SS 581860 FCCC 15 Gallon DEF Header Service Replacement Additional Parts (299)

Original SSI DEF Header, which has been discontinued, has failed and needs to be replaced. Replacement KUS DEF header must be used as replacement, but MAY require additional parts and re-routing of DEF Coolant lines and DEF lines to the new KUS DEF header 04-37616-000.

SSI TO KUS COMPARSION (15GAL DEF SYSTEM)

TYPE 1

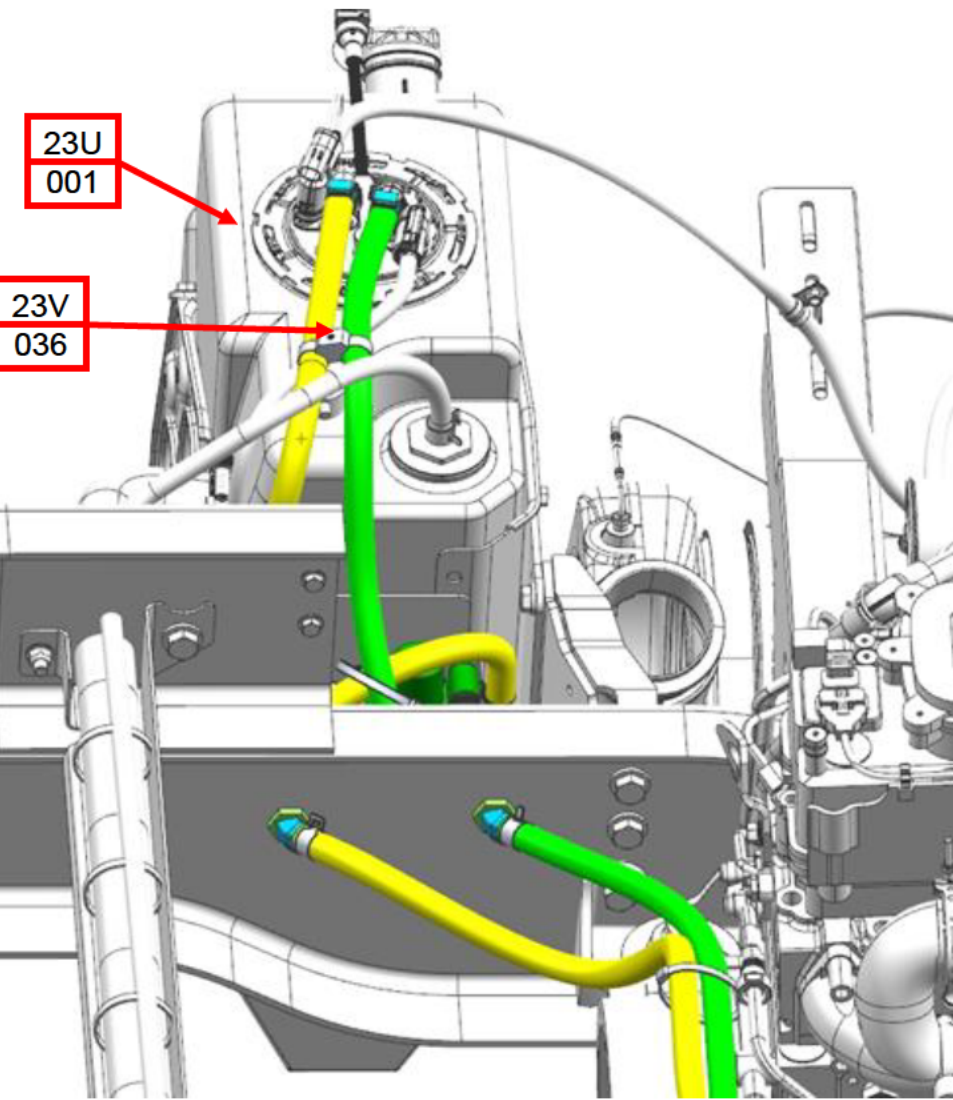
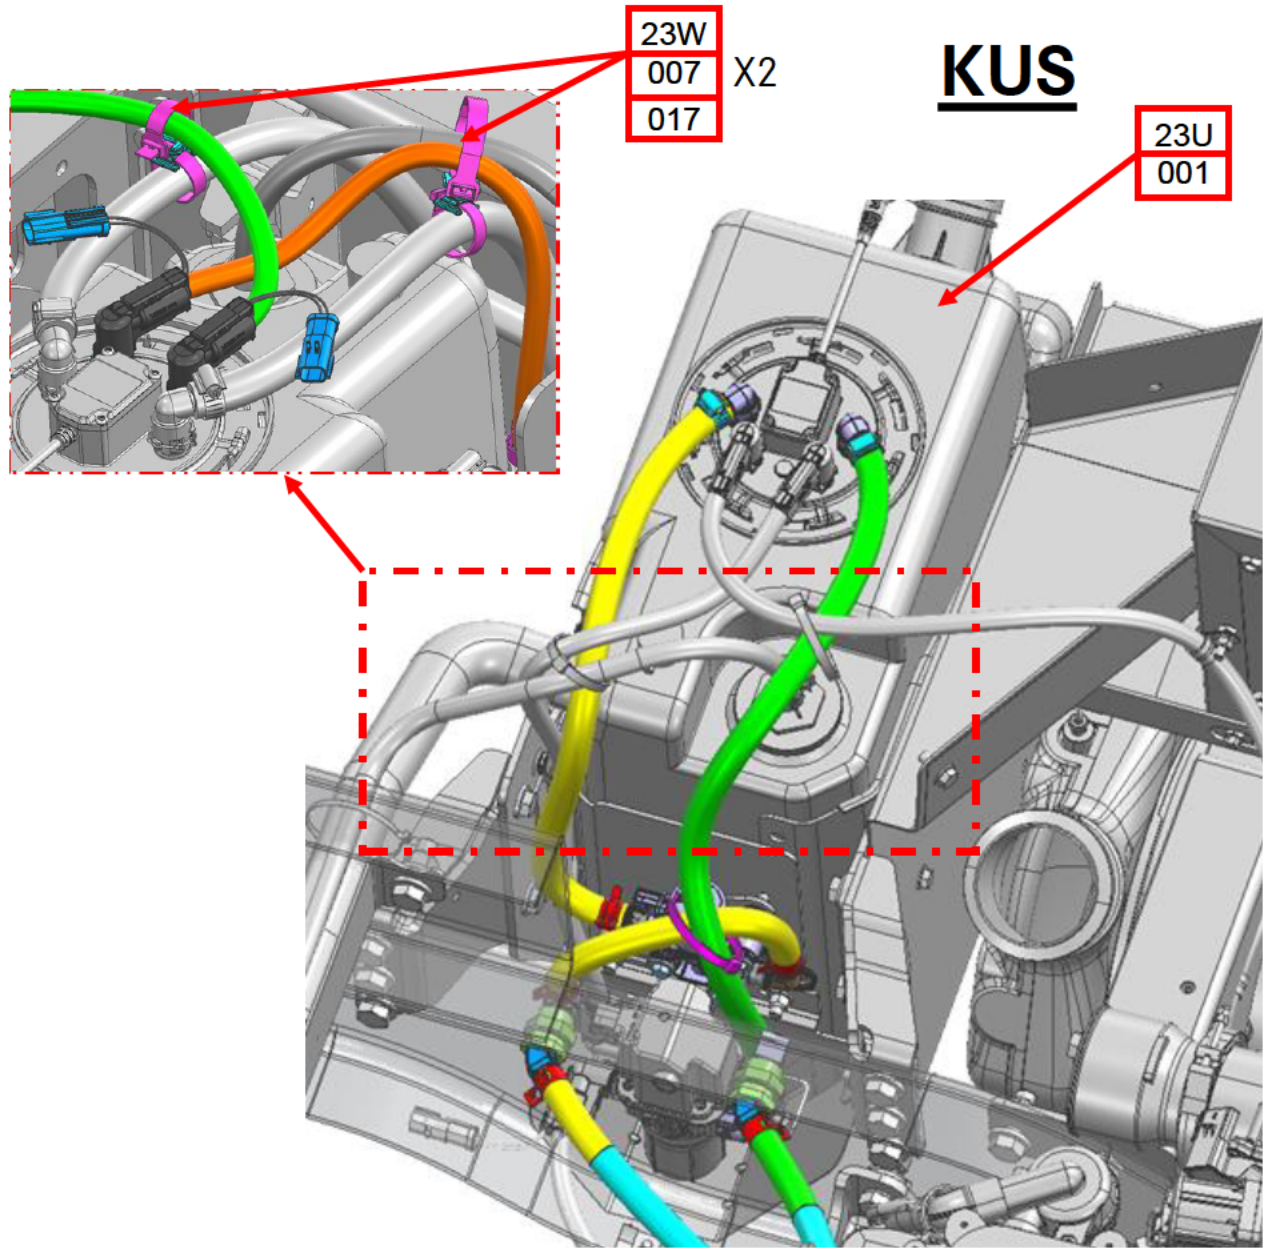
Required parts to KUS

DEF SYSTEM		SSI			KUS		
MOD	DESCRIPTION	ITEM NUMBER	ITEM	QTY	ITEM NUMBER	ITEM	QTY
23U	BILL	-	23U-C06200	-	*	23U-C06252	-
	PARTS	001	A04-36022-000	1	001	A04-37438-000	1
23V	BILL	-	23V-C05538	-	-	23V-C05570	-
	INSTALL	-	D04-35710-000	-	-	D04-37532-000	-
	PARTS	036	TYCDCT110HIR	1	-	-	-
23W	BILL	-	23W-C00372	-	-	23W-C14100	-
	INSTALL	-	D04-35626-000	-	-	D04-37545-000	-
	PARTS	-	-	-	017	23-12886-001	2
		-	-	-	-	007	23-12886-001

TYPE 2

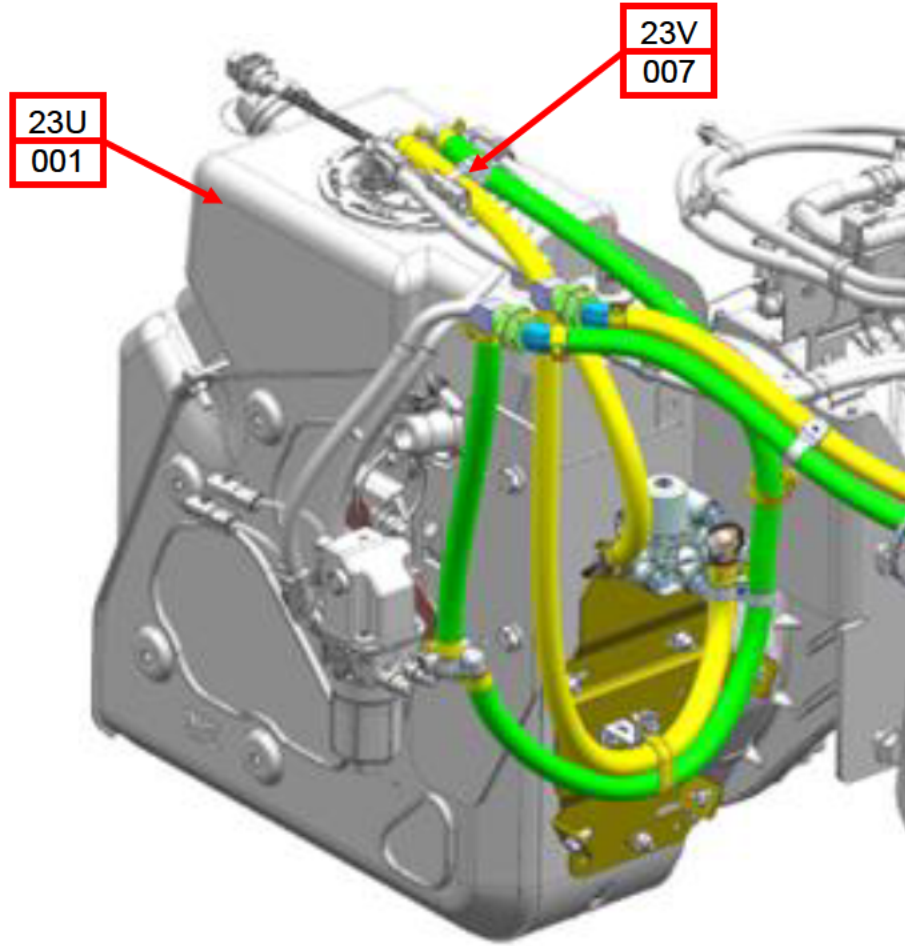
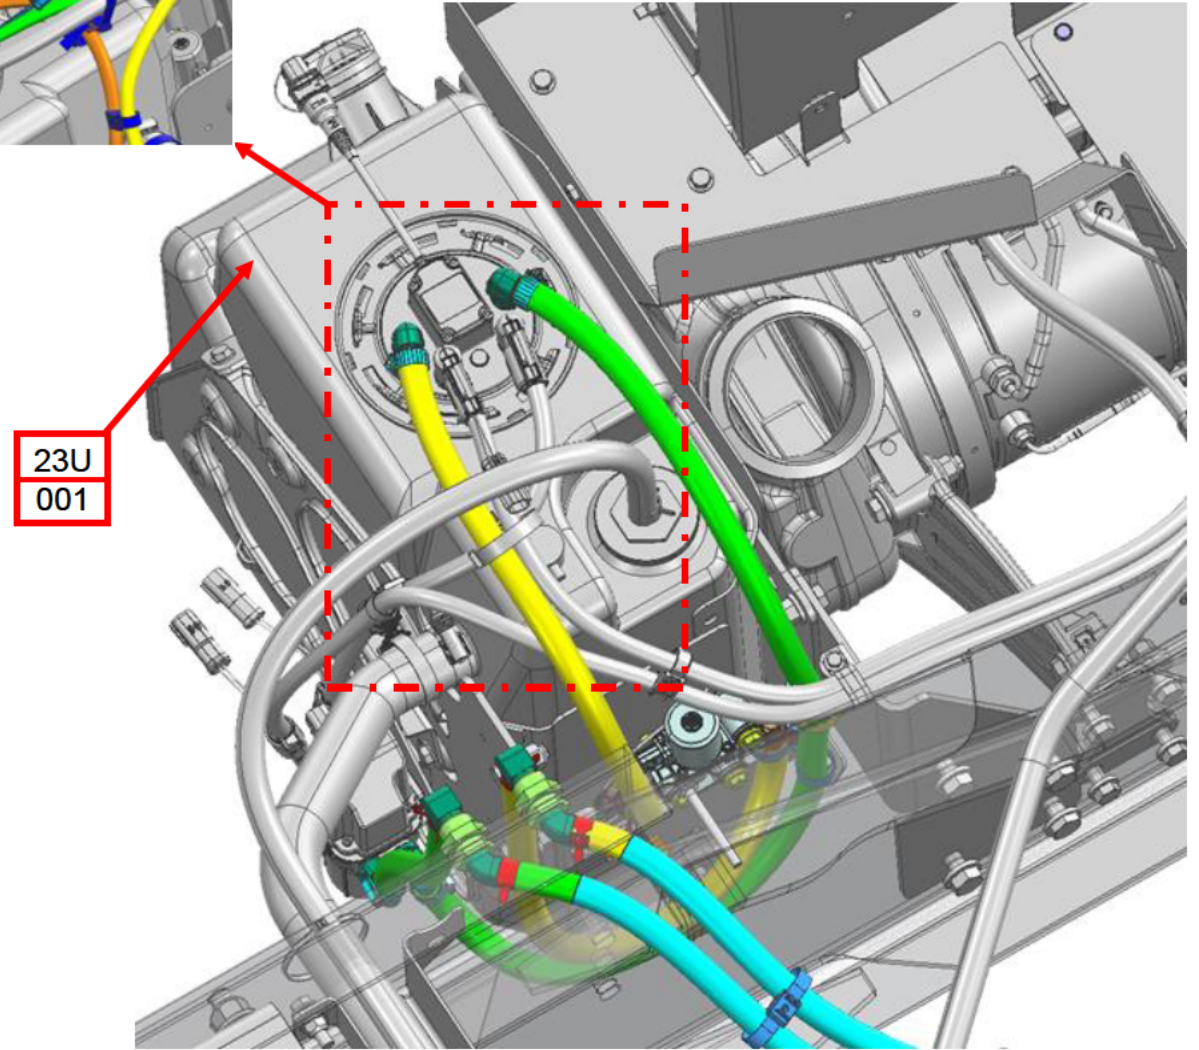
Required parts to KUS

DEF SYSTEM		SSI			KUS		
MOD	DESCRIPTION	ITEM NUMBER	ITEM	QTY	ITEM NUMBER	ITEM	QTY
23U	BILL	-	23U-C06201	-	-	23U-C06253	-
	PARTS	001	A04-36022-000	1	001	A04-37438-000	1
23V	BILL	-	23V-C05532	-	-	23V-C05569	-
	INSTALL	-	D04-35709-000	-	-	D04-37531-000	-
	PARTS	007	TYCDCT110HIR	1	-	-	-
23W	BILL	-	23W-C00385	-	-	23W-C14104	-
	INSTALL	-	D04-35665-000	-	-	D04-37550-000	-
	PARTS	-	-	-	014	23-09796-509	2
		-	-	-	004	23-12886-001	1

TYPE 3

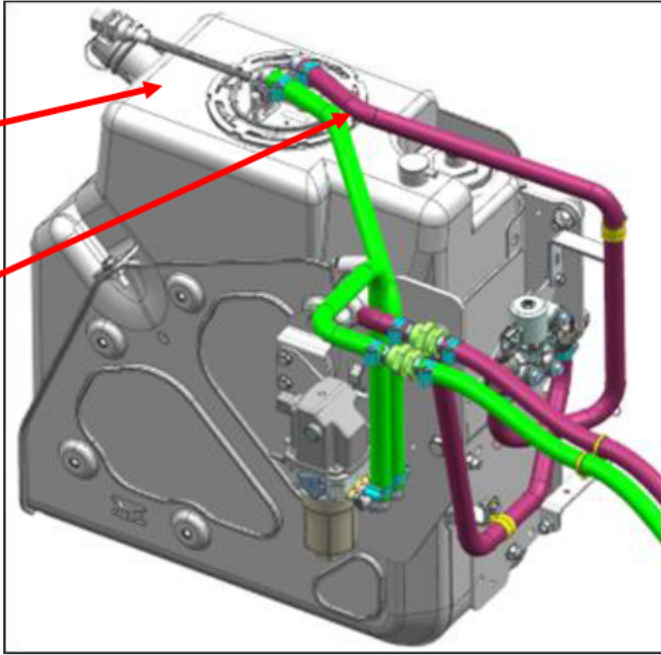
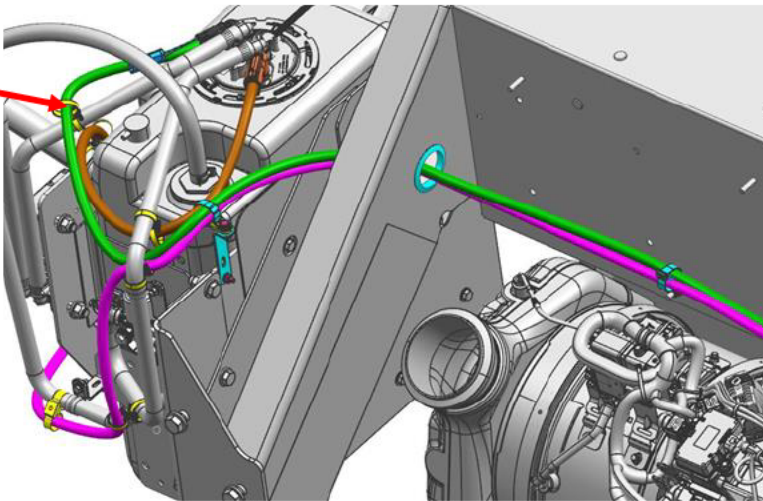
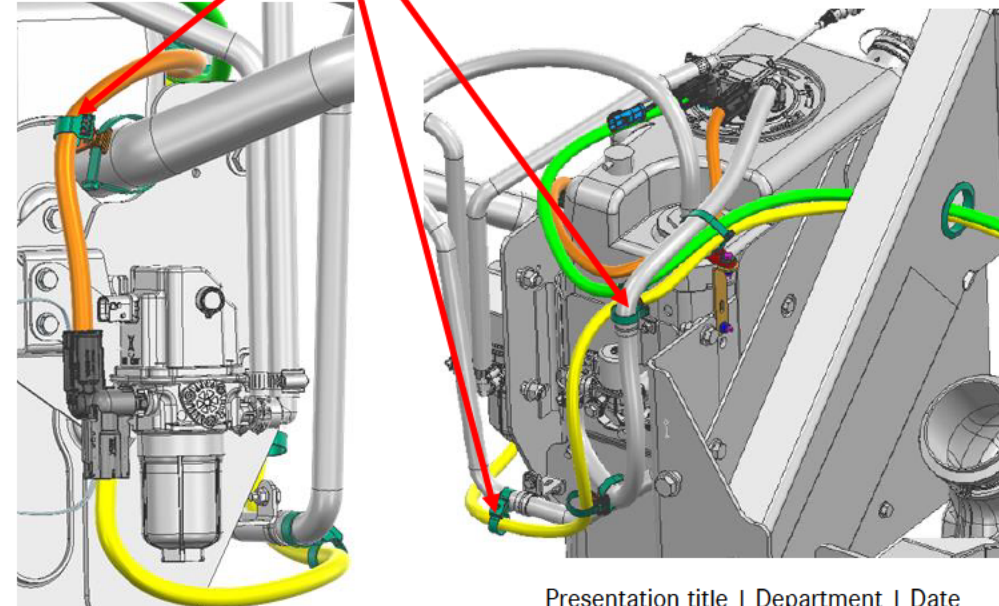
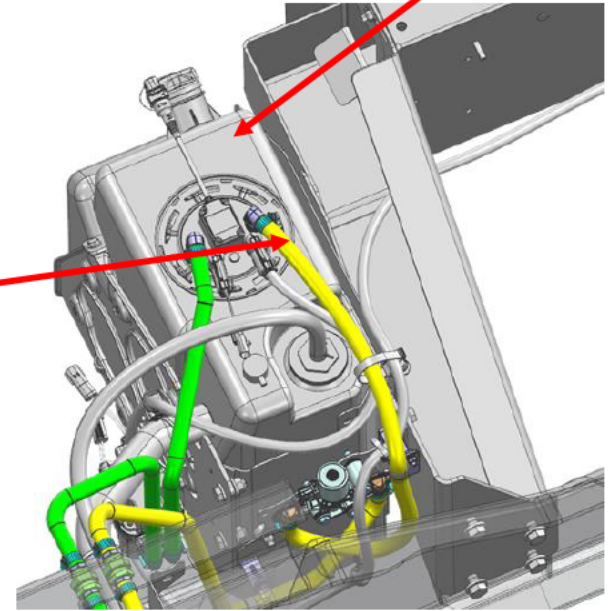
Required parts to KUS

DEF SYSTEM		SSI			KUS		
MOD	DESCRIPTION	ITEM NUMBER	ITEM	QTY	ITEM NUMBER	ITEM	QTY
23U	BILL	-	23U-C06202	-	-	23U-C06254	-
	PARTS	001	A04-36022-000	1	001	A04-37438-000	1
23V	BILL	-	23V-C05540	-	-	23V-C05571	-
	INSTALL	-	D04-35789-000	-	-	D04-37533-000	-
	PARTS	002	04-34462-000	1	002	48-00081-062	3FT
23W	BILL	-	23W-C00392	-	-	23W-C14105	-
	INSTALL	-	D04-35683-000	-	-	D04-37551-000	-
	PARTS	013	23-09796-629	10	013	48-25131-001	7.5IN
		012	23-12886-001	2	004	-	-
		-	-	-	006	23-13746-000	6
014		48-25131-001	7.5IN	-	-	-

TYPE 4

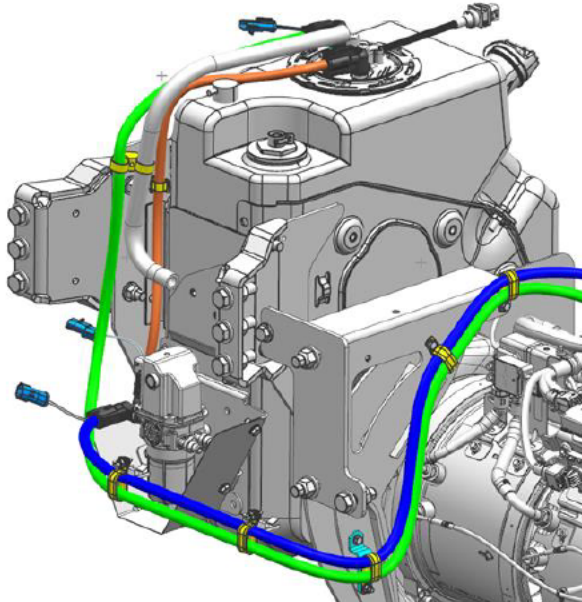
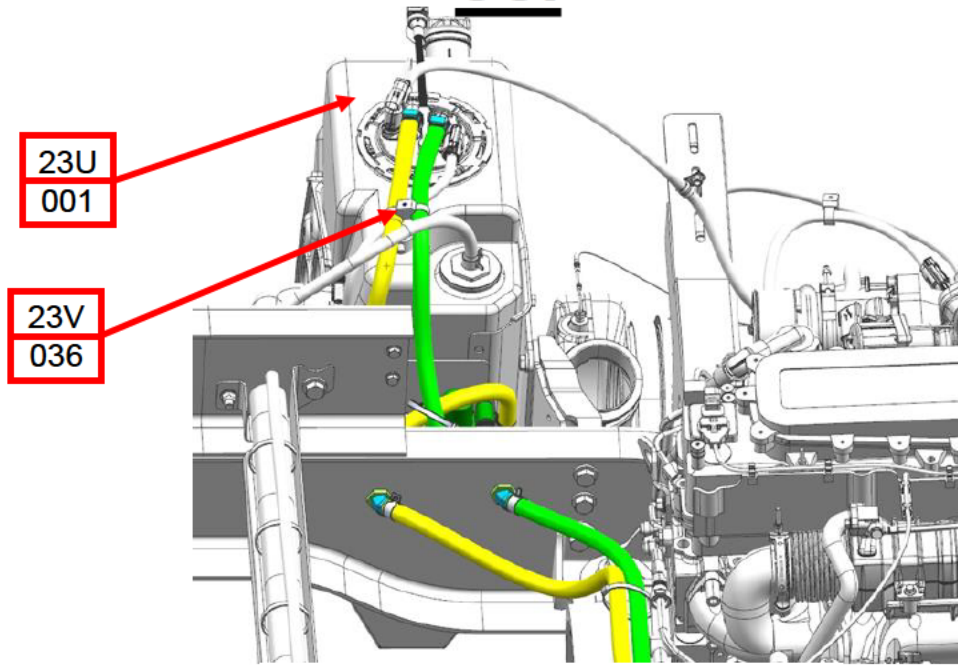
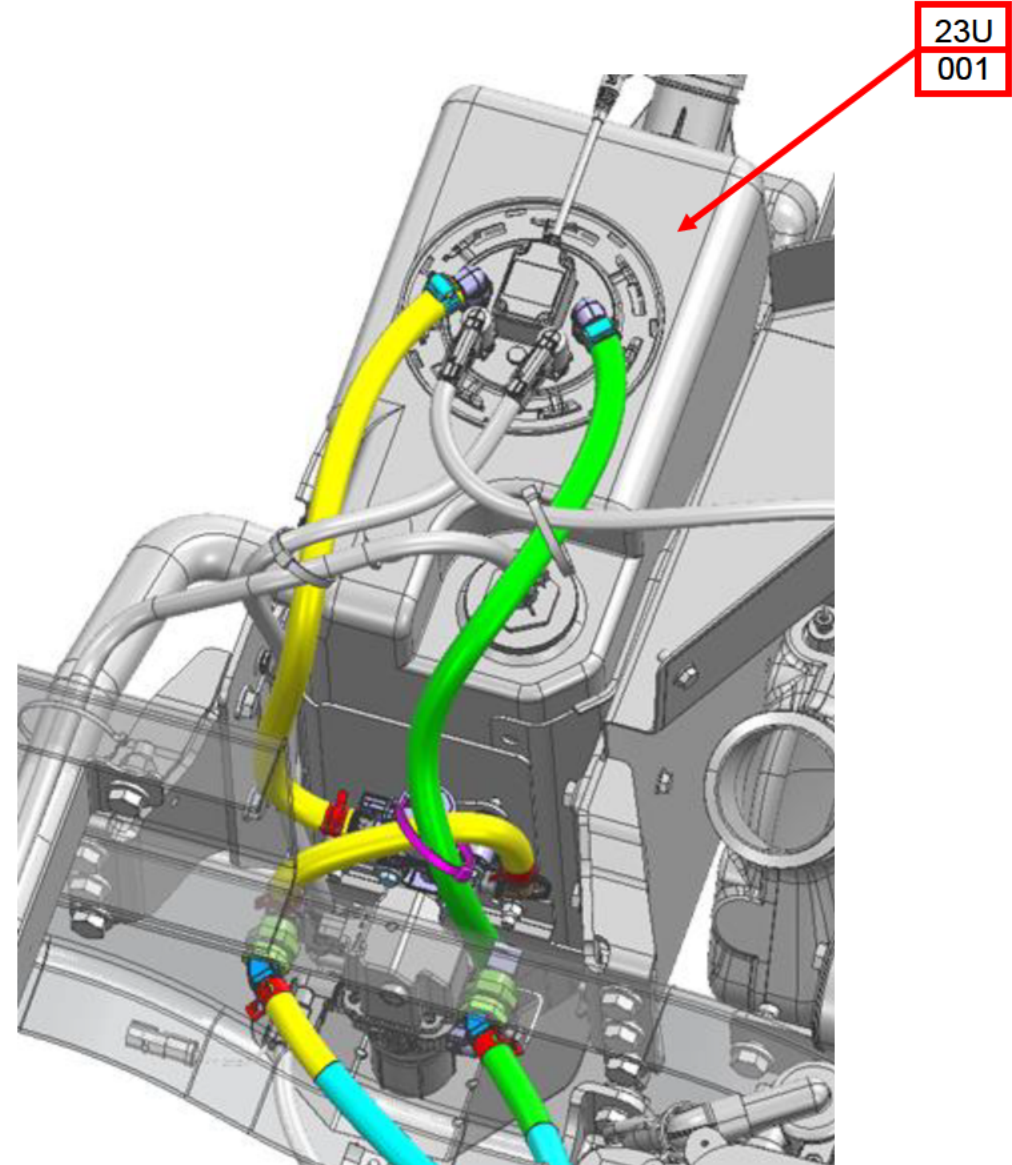
Required parts to KUS

DEF SYSTEM		SSI			KUS		
MOD	DESCRIPTION	ITEM NUMBER	ITEM	QTY	ITEM NUMBER	ITEM	QTY
23U	BILL	-	23U-C06204	-	*	23U-C06255	-
	PARTS	001	A04-36022-000	1	001	A04-37438-000	1
23V	BILL	-	23V-C05538	-	-	23V-C05570	-
	INSTALL	-	D04-35710-000	-	-	D04-37532-000	-
	PARTS	036	TYCDCT110HIR	1	-	-	-
23W	BILL	-	23W-C00384	-	-	23W-C14103	-
	INSTALL	-	D04-35634-000	-	-	D04-37549-000	-
